December 7, 2021

**NRHS ANNEX ROOF REPLACEMENT
For
North Rockland Central School District
MSA File No. 41056**

Re: ADDENDUM NO. 1

Drawing No.
A-100

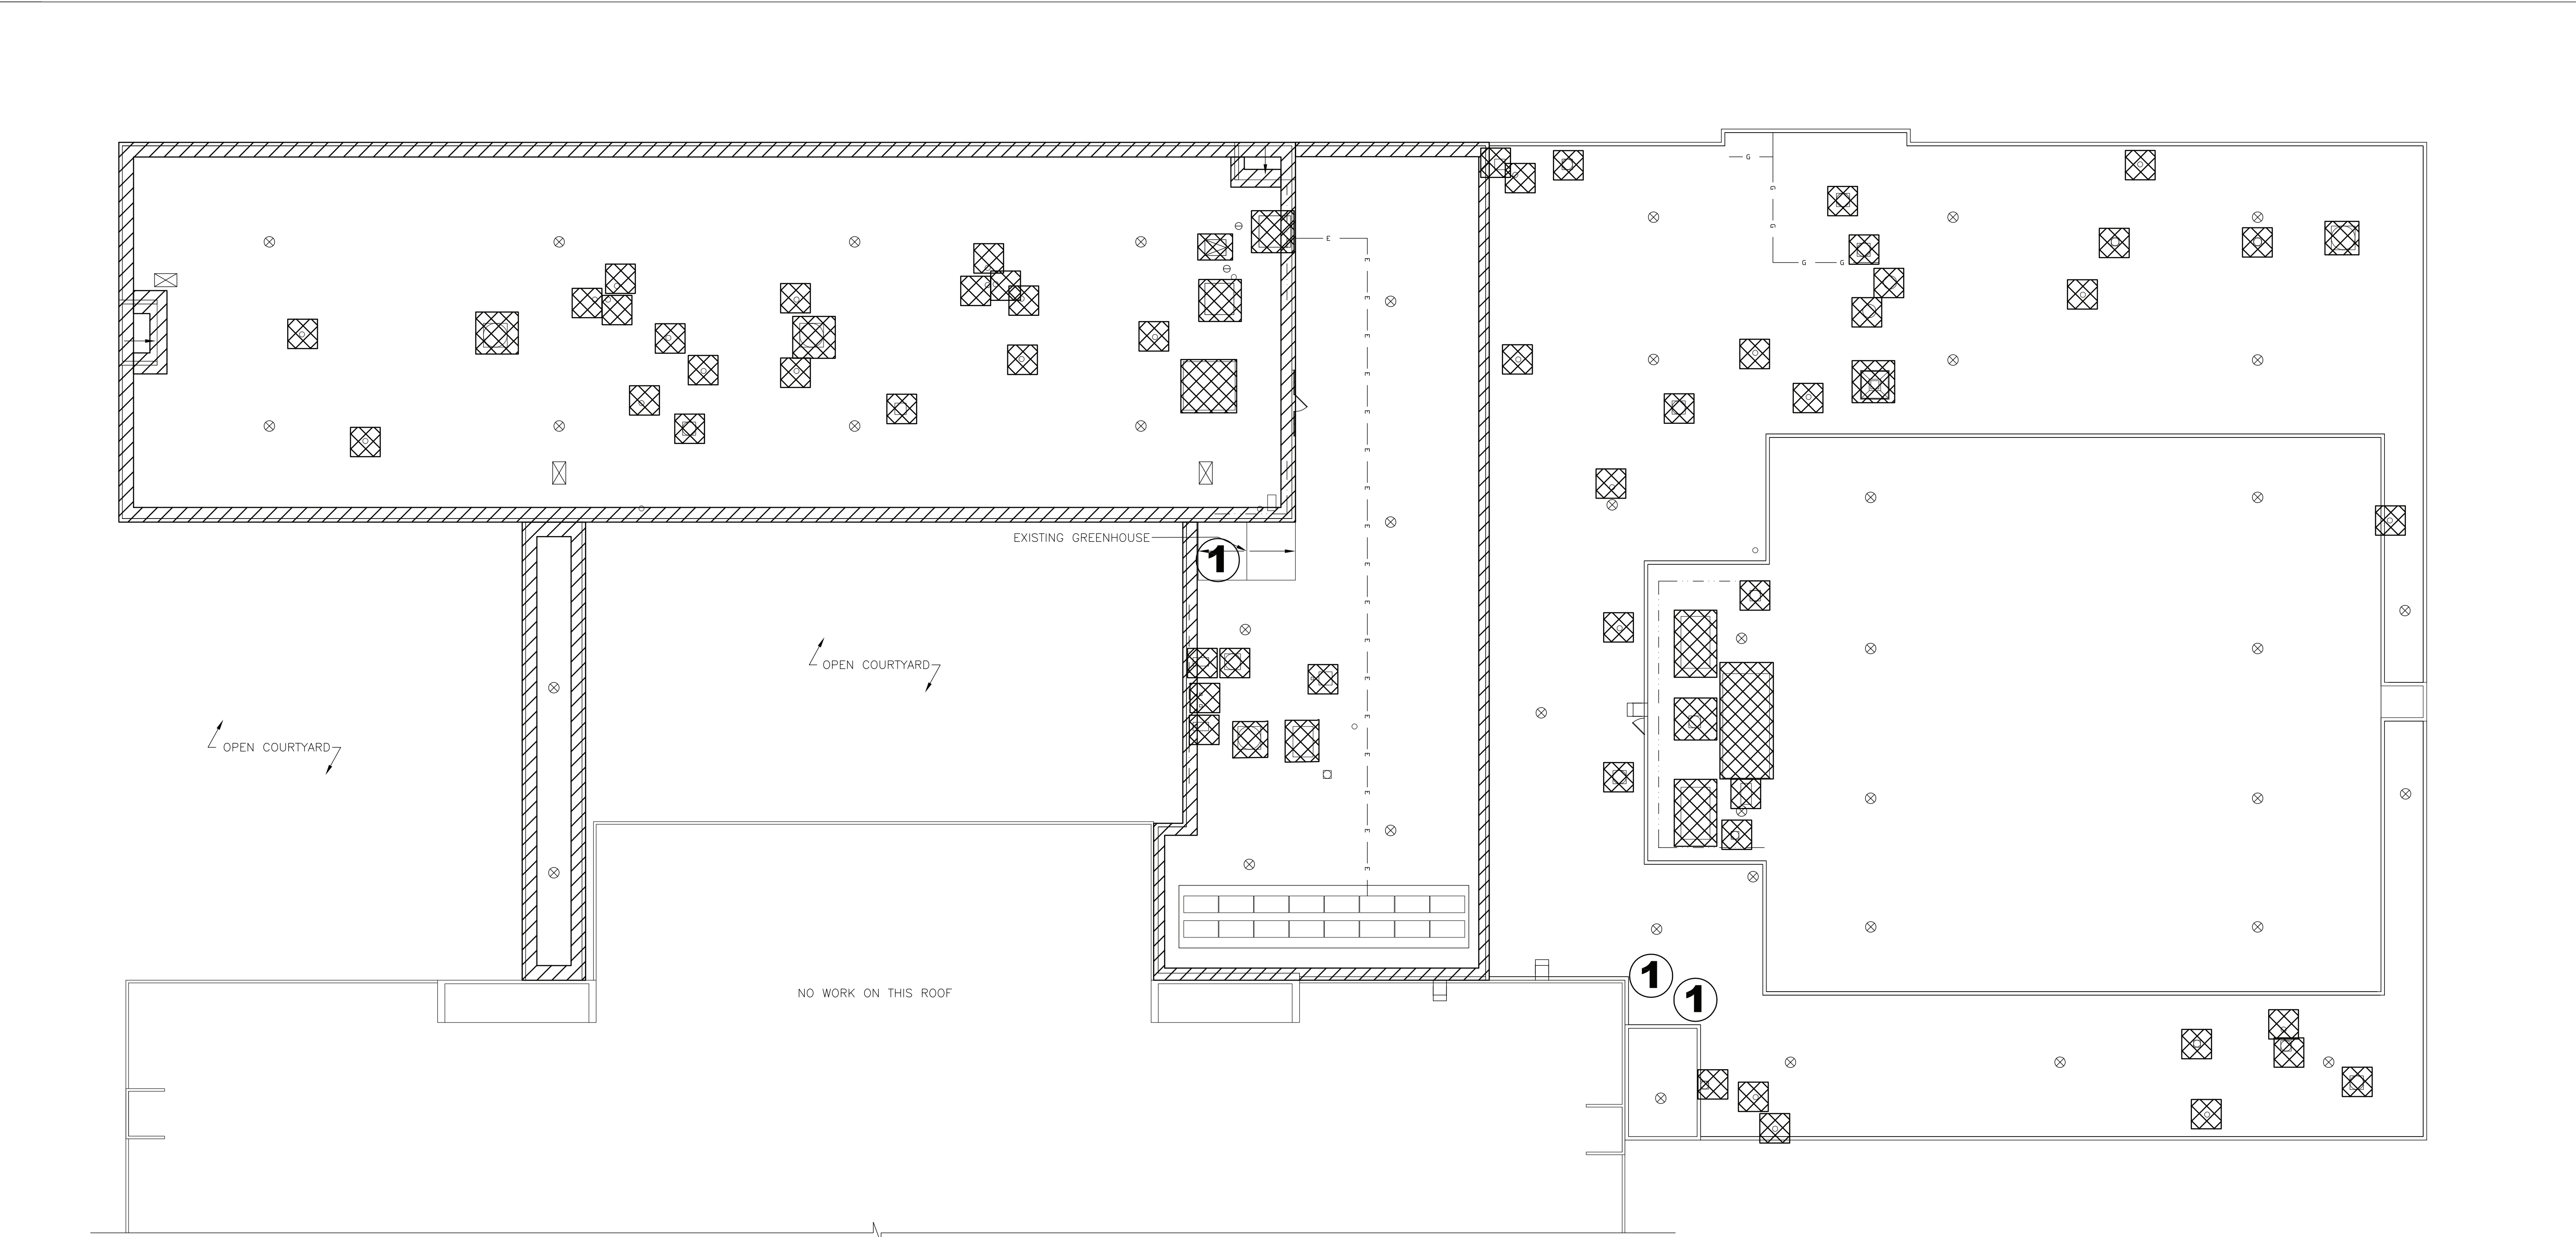
- 3) Item 1.02.A Time of Completion has been revised. Use attached revised Bid Form 03000R Roofing Construction Bid Form.
- 4) The small roof area at the Southwestern corner of the Annex 1 Story section is part of Alternate No. 1 work, not base bid. The Alternate Roofing Area Plan has been revised to clarify this. Use revised drawing A-100 Annex Roof Plan.

- 5) Various walls require raising of weeps. Note 4 and areas tagged to detail 4/A-501 on drawing A-100 Annex Roof Plan show areas of weep raising. Drawing A-100 Annex Roof Plan has been revised to further clarify areas the need weep raising. The scope of weep raising fall under base bid and alternate work and correspond to the Alternate Roofing Area Plan on A-100. Use attached revised drawing A-100 Annex Roof Plan.
